Application No.: PL8625

Description :	
Address :	
Record Type :	PLAT

PLAT OF: FLOUR BLUFF HEIGHTS BLOCK 4, LOT 13R AND 14R

PLAT OF:
FLOUR BLUFF HEIGHTS
BLOCK 4, LOT 13R AND 14R

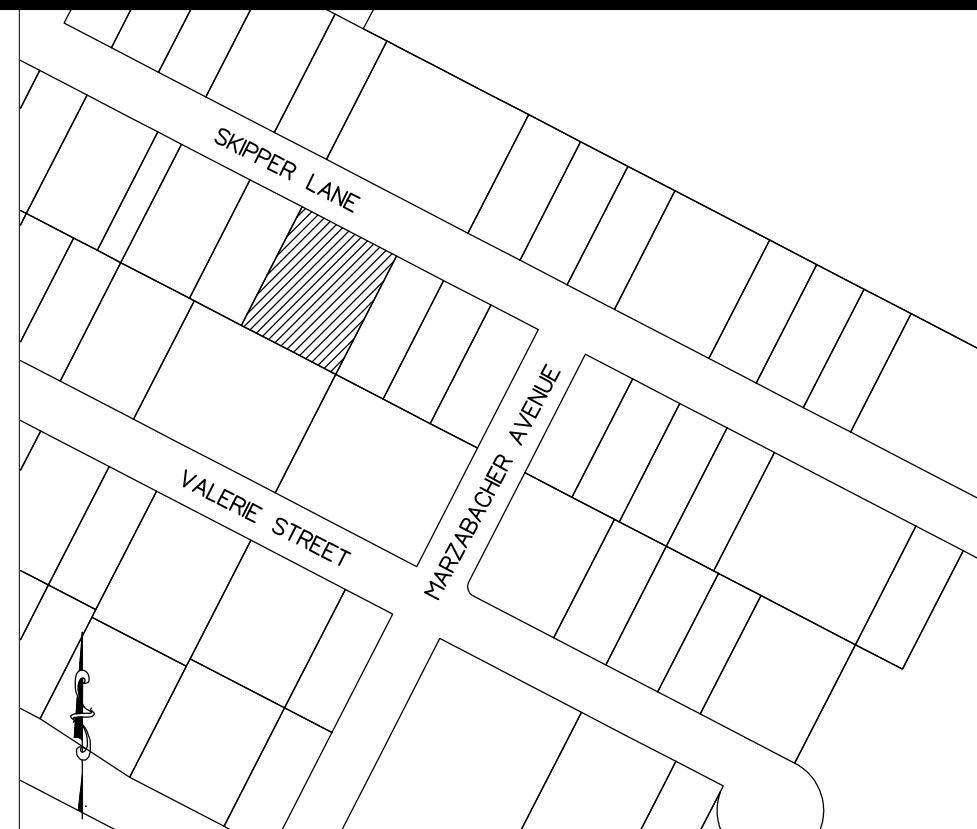
21	1	Note	Mark Zans : LD	Open	Depict LCRA easement for overhead power lines. At this time awaiting LCRA communication to determine easement width.

Remove Lot 13R
text, also the word
and.
Should read Lot
14R only.
